## Fellowship Christian School 2007 Approval Items in Non-compliance

### Grading & Drainage

Gullies

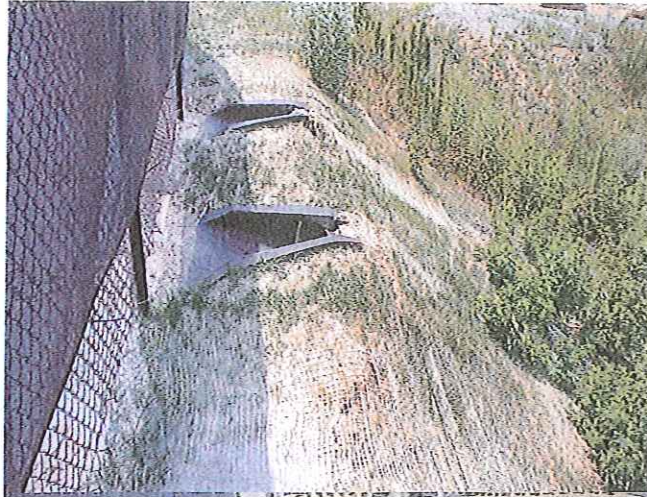
stabilized area

Gullies are stabilized and seeded with love grass, we are monitoring growth and will reseed if necessary

Down Drains, Grassing

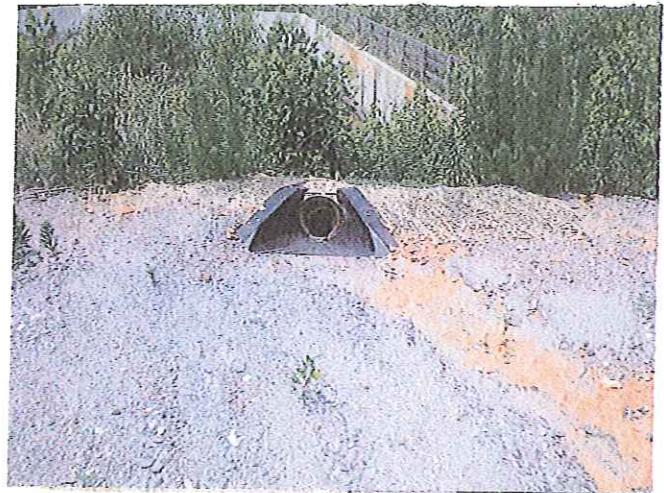
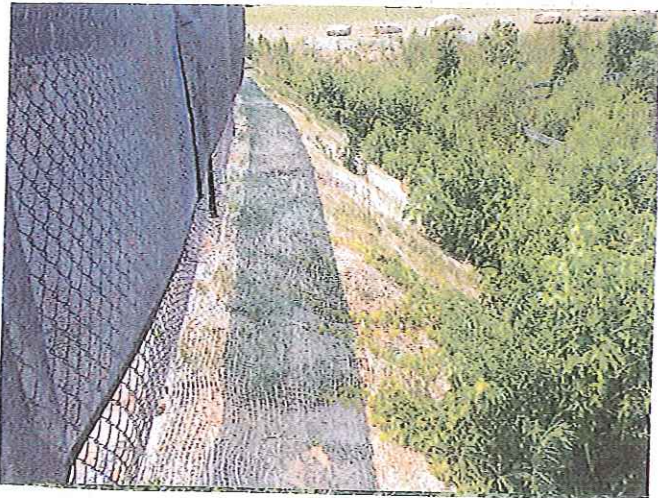
stabilized area

Down drains are installed and work properly.
